Addendum 02 for RFB 943600-01

Project Name: Terrace Hill Elevator Replacement
DAS RFB #: 943600-01
DAS Project #: 9436.00
Date: 1/30/2025

State of Iowa
Terrace Hills Elevator Replacement
Addendum #2
01/29/2025

ELECTRICAL - ATTIC
1/4" = 1'-0"

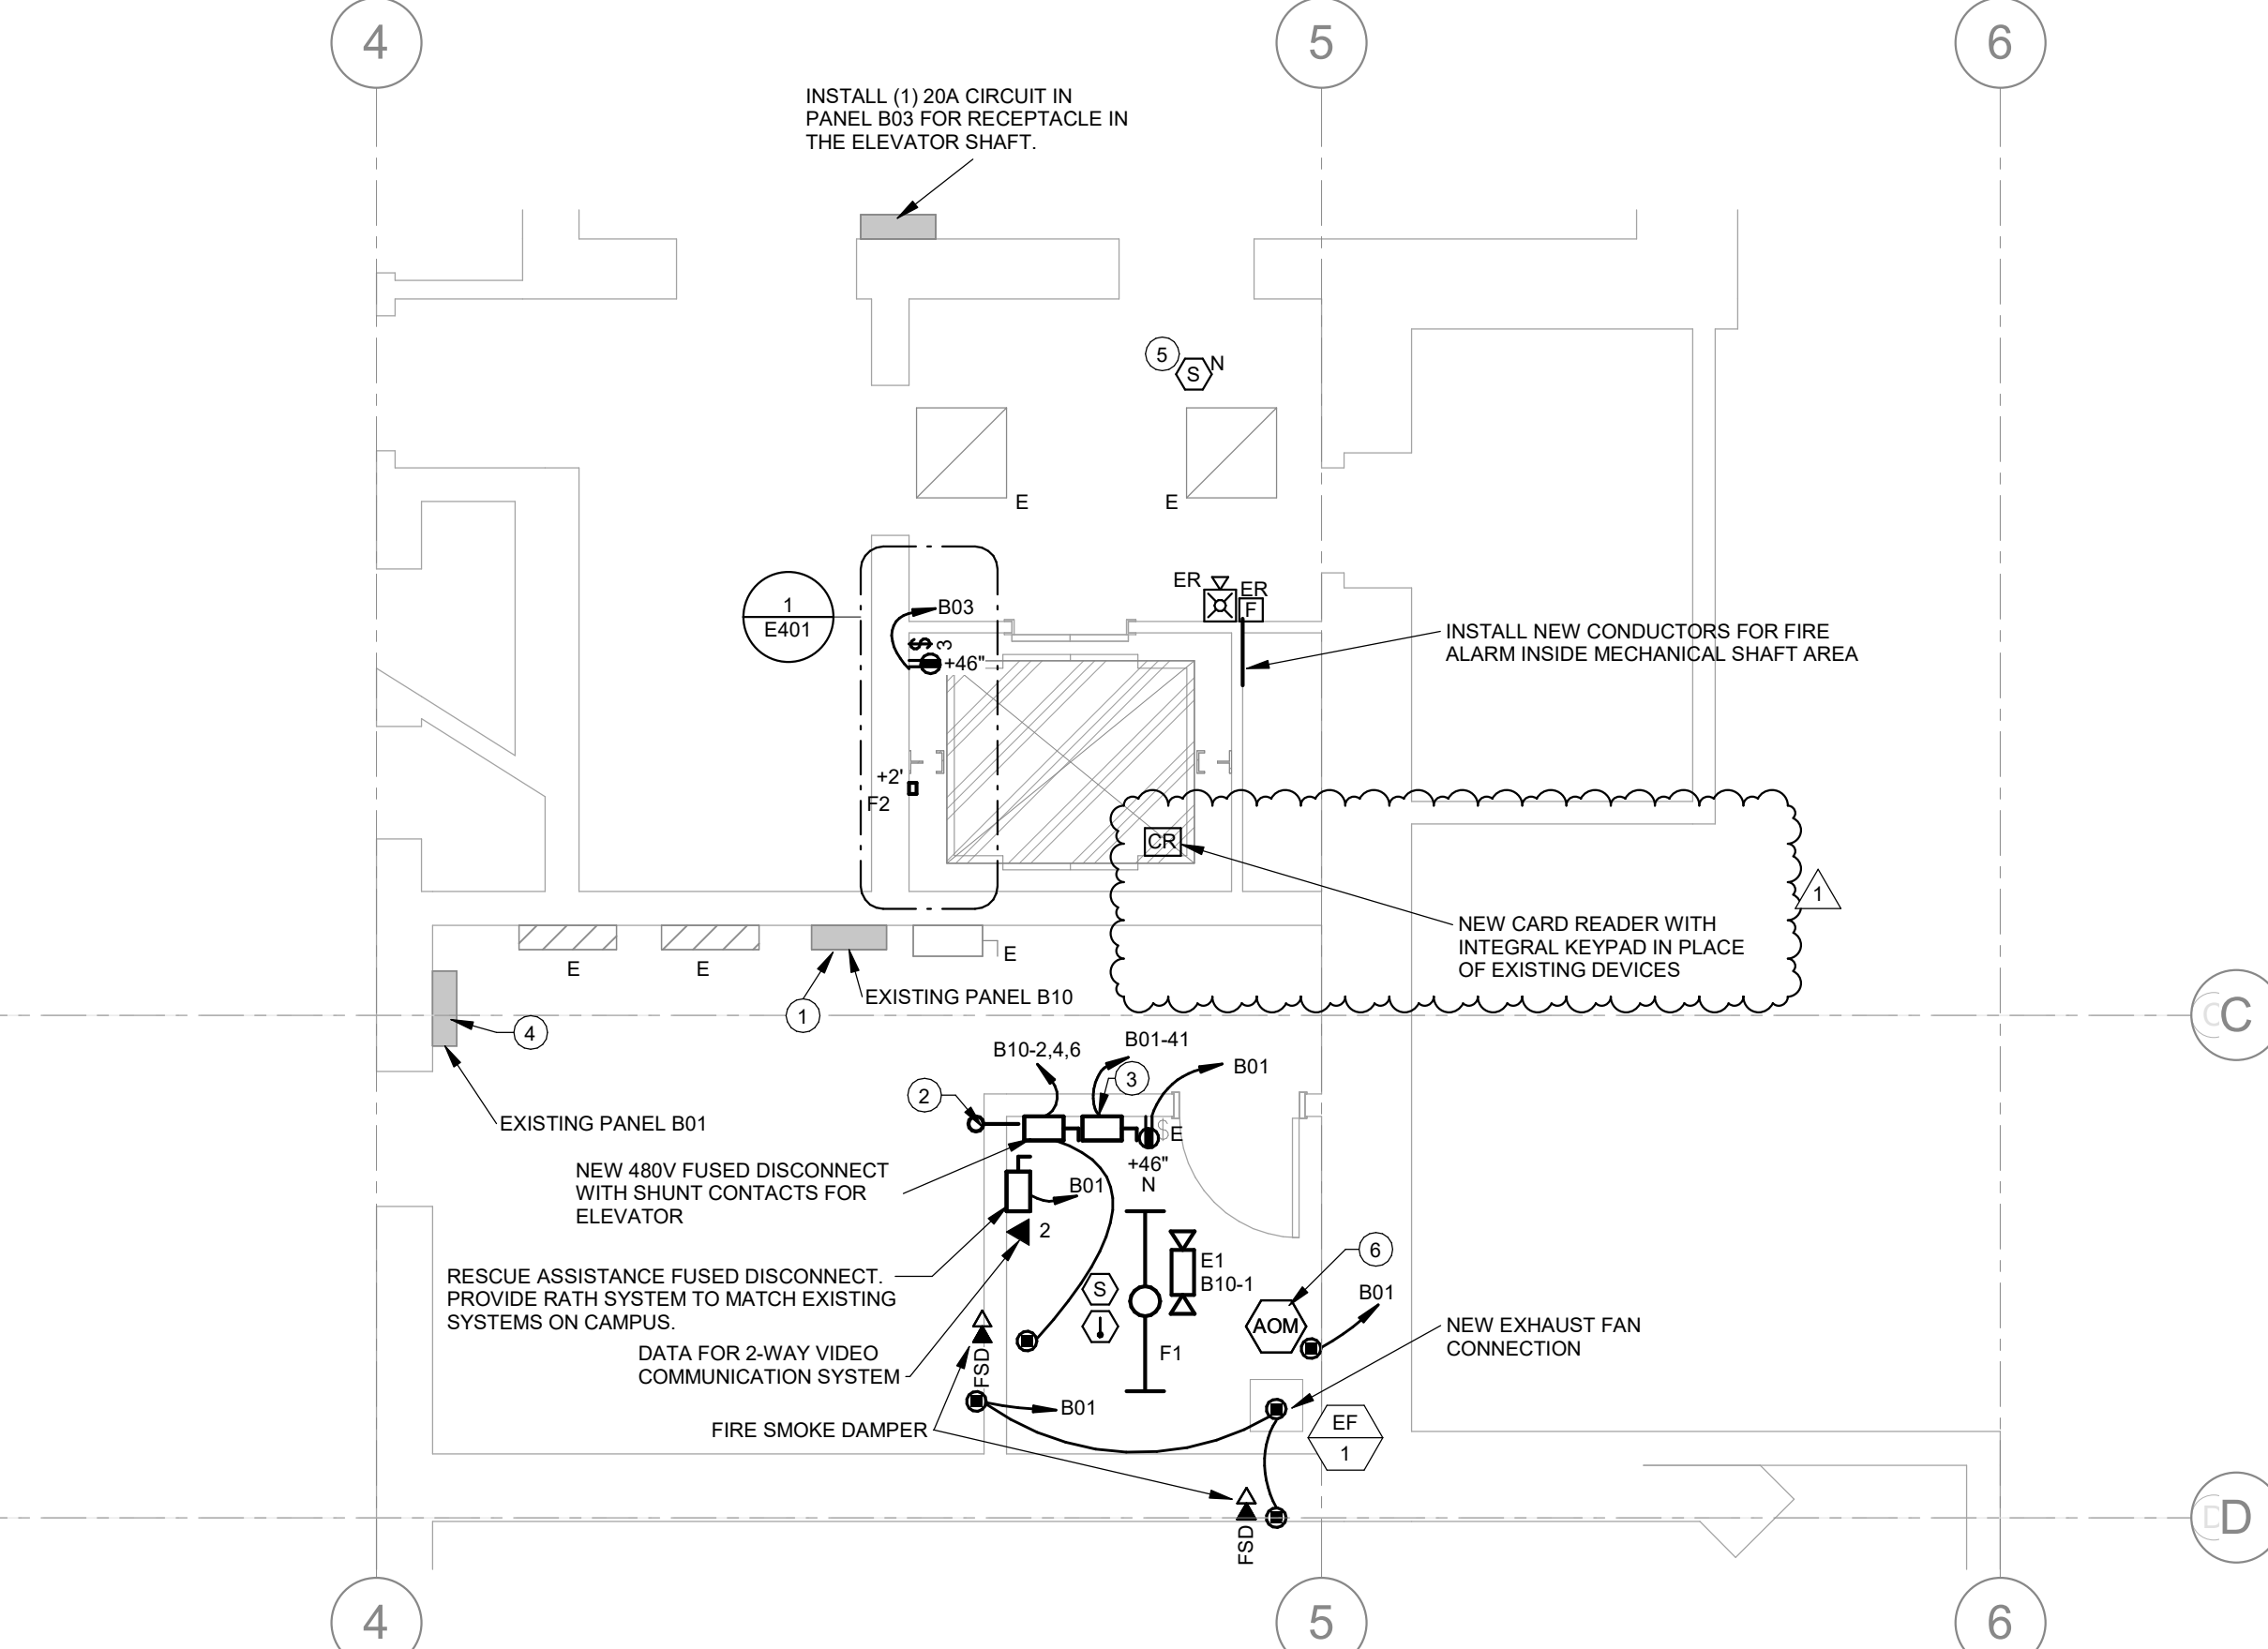
1. Drawing E101 – ELECTRICAL SHEET
 - a. CLARIFY IDF location in basement for installation of the new data cabling.
 - b. REVISE circuit for the lighting in the elevator shaft to the attic panelboard 401.
 - c. REMOVE additional card reader in the elevator cab. Only (1) card access location will be required located on the main elevator control panel.
 - d. Refer to attached full size sheet E101.

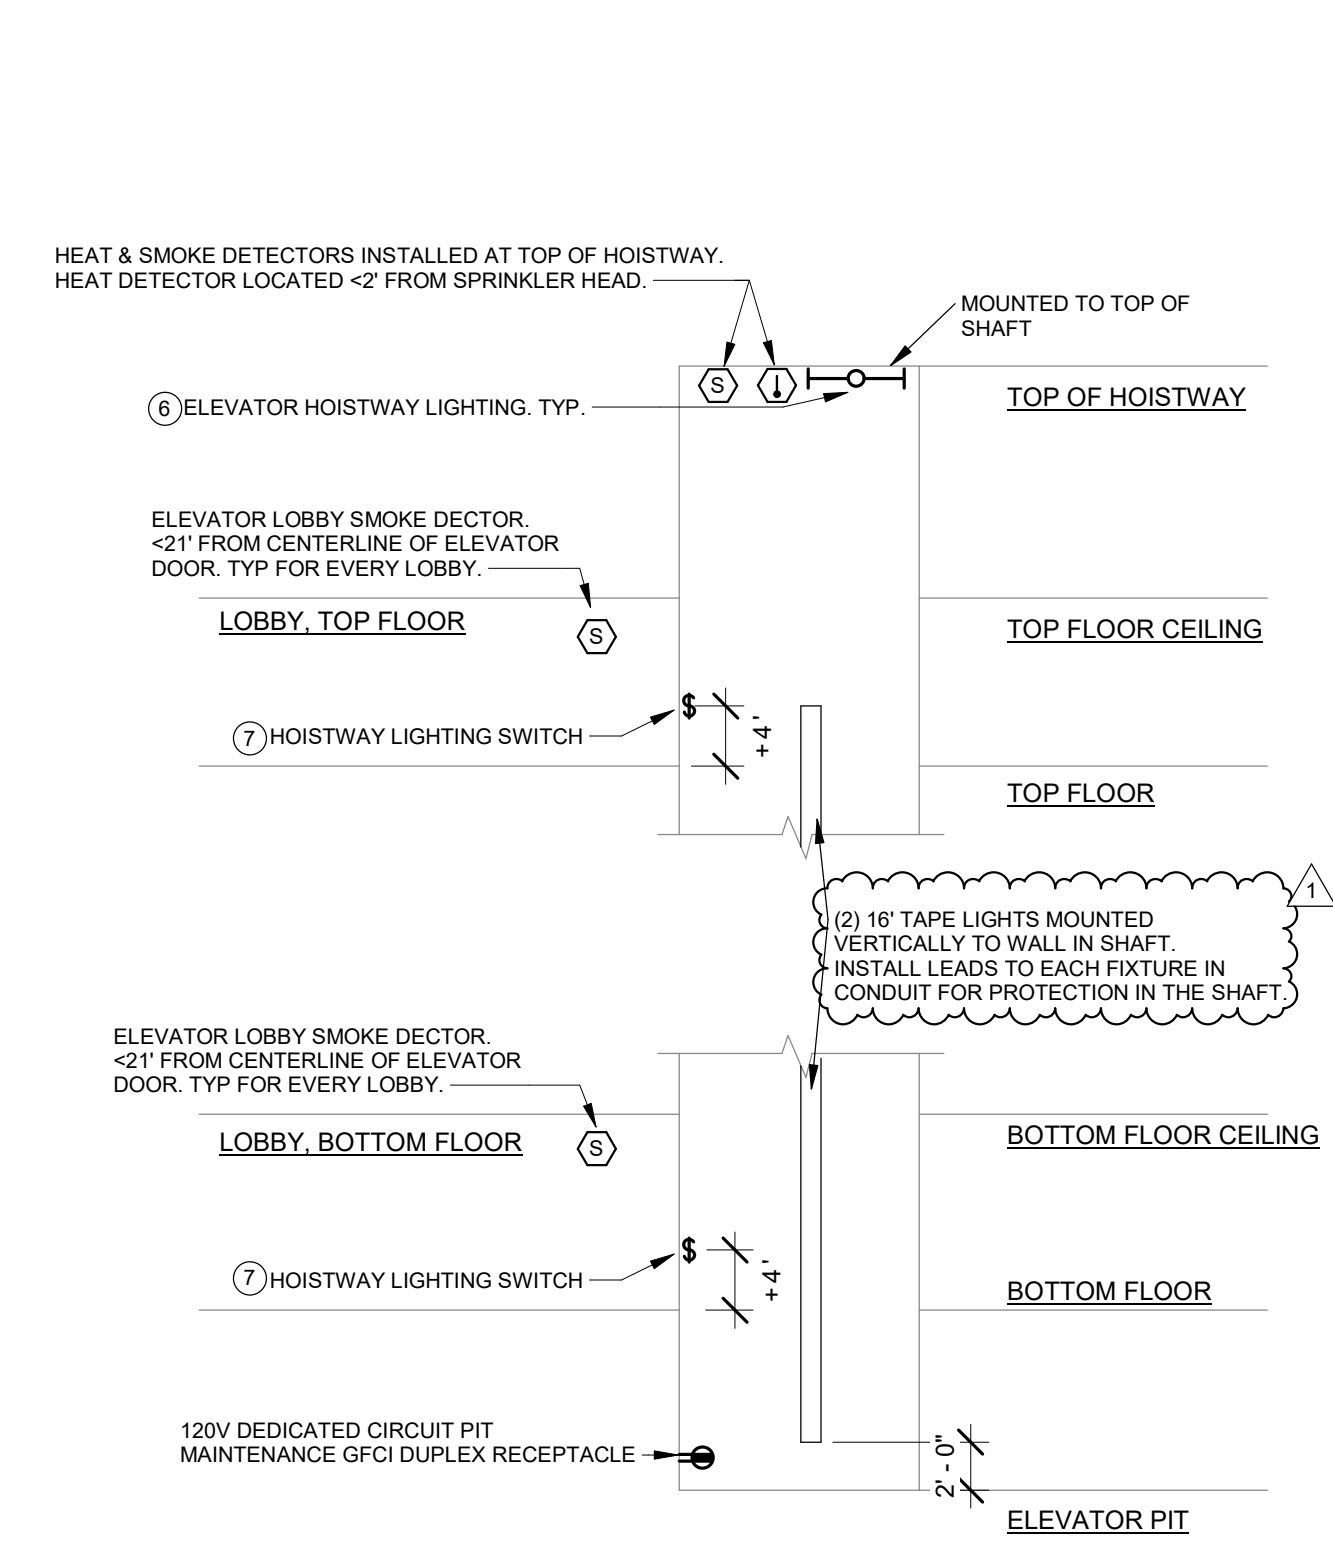
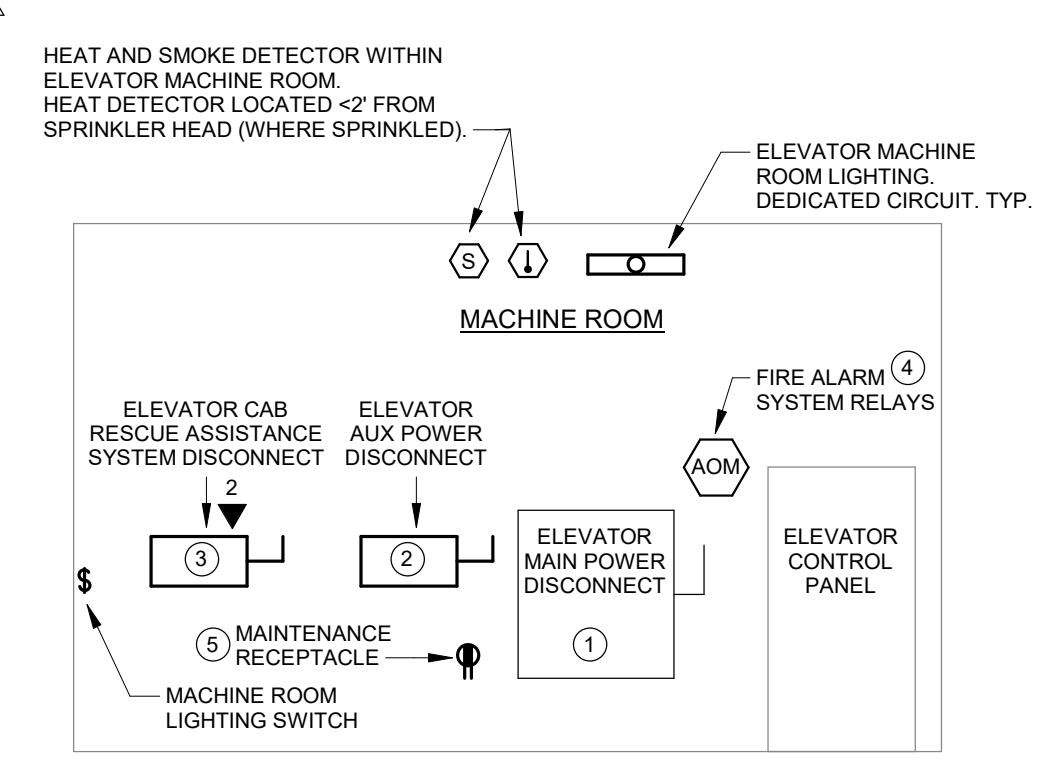
2. Drawing E401 – ELECTRICAL SCHEDULES & DETAILS
 - a. REVISE description of F1 and F2 lights.
 - b. CLARIFY that the tape lighting in the shaft will need leads installed in the shaft that extend to drivers.
 - c. CLARIFY the fire alarm panel is being replaced by the owner.
 - d. Refer to attached full size sheet E401.
